Product/Process Change Notice (PCN) WÜRTH ELEKTRONIK Major change ☐ Minor change Product Mark PCN #: WE WPCC 20150924 Date Code Packaging Product Affected: 760308103203 760308103204 Others PCN Date: October 13th 2015 Effective Date: February 1st 2016 Contact: Product Management Yes Attachment: ⊠ No Phone: +49 (0) 7942 - 945 5001 Samples: Fax: +49 (0) 7942 - 945 5179 E-mail: pcn.eisos@we-online.de

DESCRIPTION AND PURPOSE OF CHANGE:

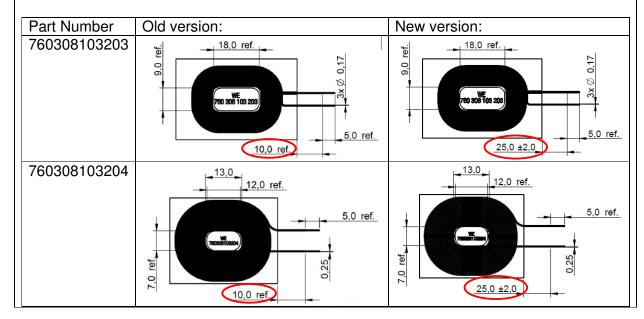
In line with internal standardisation, Würth Elektronik will change the lead length.

The lead length is changed from 10mm to 25mm. All receiver coils in the WPCC family will have the same lead length.
